**DEFENSE NUCLEAR FACILITIES
SAFETY BOARD**

February 2, 2015

Staff Issue Report

SUBJECT: Seismic Control Strategy Deficiencies in the Safety Design Strategy for the High-Level Waste Facility

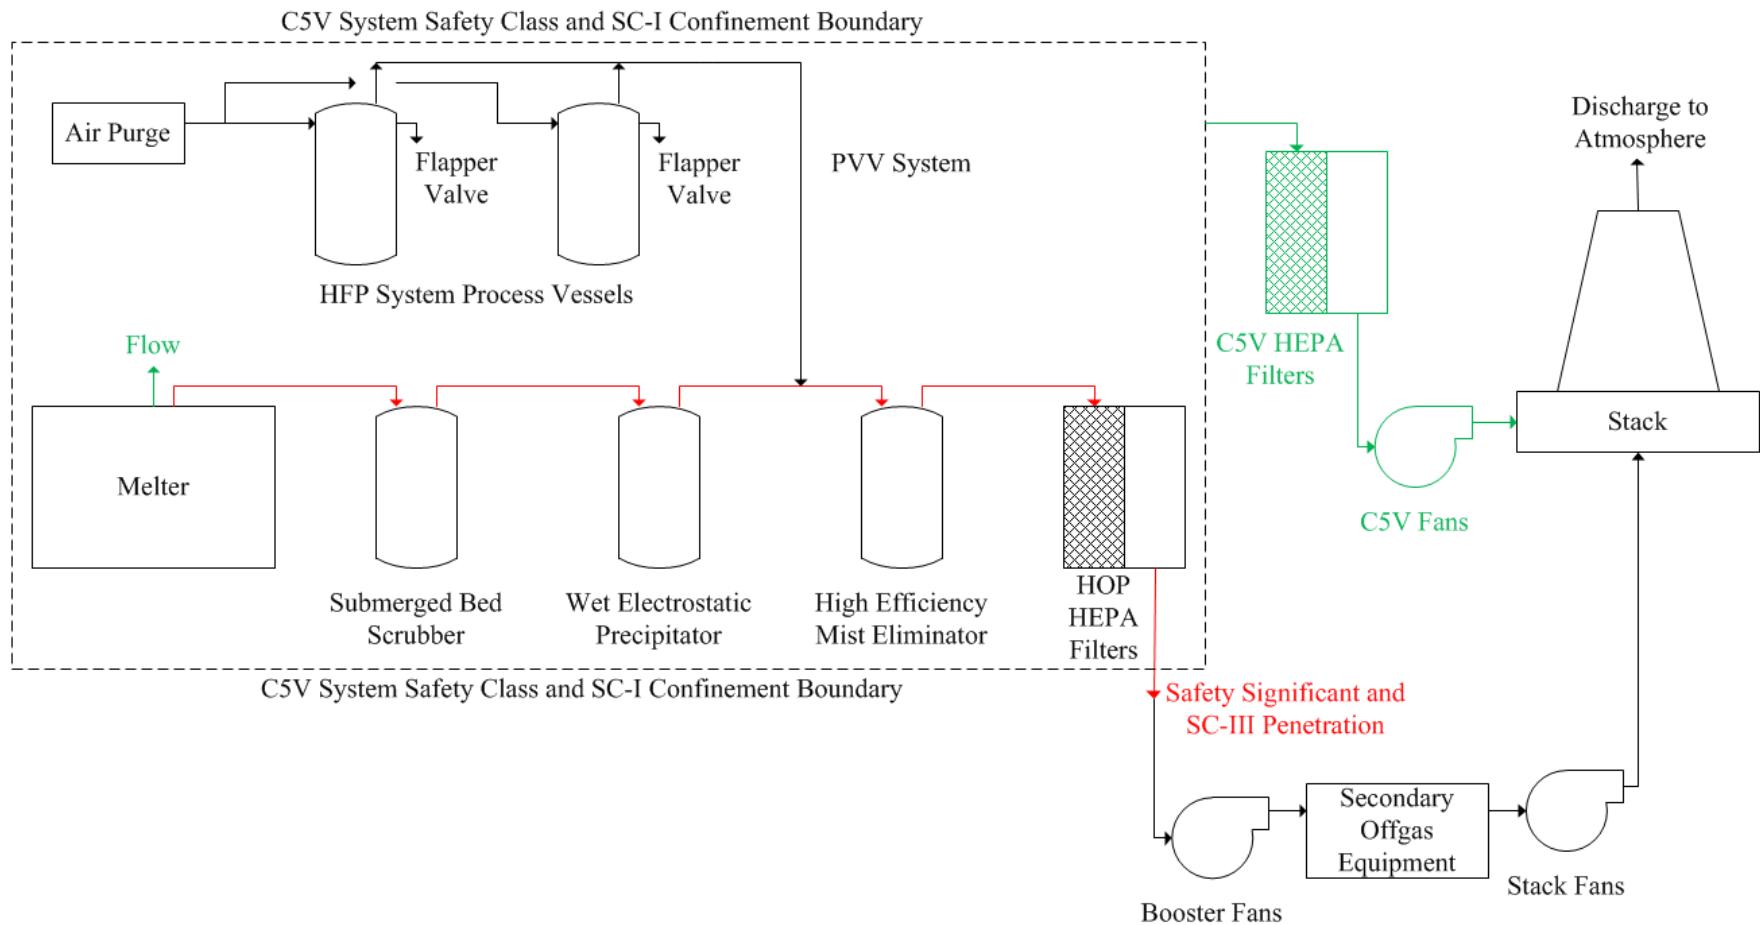
Safety Concerns. SC-III SSCs may fail following a seismic DBA. A robust safety control strategy for a seismic DBA would consider possible failure states of SC-III SSCs. For example, DOE Guide 420.1-2, *Guide for the Mitigation of Natural Phenomena Hazards for DOE Nuclear Facilities and Nonnuclear Facilities* [4], states: “The design and evaluation process should consider potential damage and failure of SSCs due to both direct natural phenomena effects, including common cause, and indirect natural phenomena effects, including interaction with other SSCs.” Implementing the SDS safety control strategy for a seismic DBA could result in several potential unfiltered flowpaths to the public and the workers. These flowpaths are explained below:

- The SDS proposes downgrading the submerged bed scrubber and the HOP system HEPA filters to safety significant and SC-III. As a result, a potential unfiltered release pathway for radioactive offgas exists to occupied spaces outside the confinement boundary of the C5V system and possibly to the environment. Figure 1 illustrates this potential flowpath.
- Following a seismic DBA, the HFP system vessels will be above atmospheric pressure. Because the SDS proposes downgrading the HOP system HEPA filters to safety significant and SC-III, a potential unfiltered release pathway exists to occupied spaces outside the confinement boundary of the C5V system and possibly to the environment. Figure 2 illustrates this potential flowpath.

Conclusion. Alternative engineered controls may be available that could be added to the design to offset downgrading the submerged bed scrubber and HOP HEPA filters to safety significant and SC-III. The engineered controls would be designed to prevent the unfiltered releases through the confinement boundary of the C5V system following a seismic DBA. However, with the existing design, members of the Board’s staff conclude the proposed safety and seismic downgrade to the submerged bed scrubber and HOP HEPA filters does not meet DOE requirements. The content and nuclear safety control strategy outlined in the SDS will have direct implications on the safety basis. Therefore, a deficient SDS may lead to incomplete reconstitution of the PDSA and a safety basis that does not meet the requirements of 10 CFR 830. The SDS safety control strategy for a seismic DBA would be strengthened by addressing the safety concerns in this report.
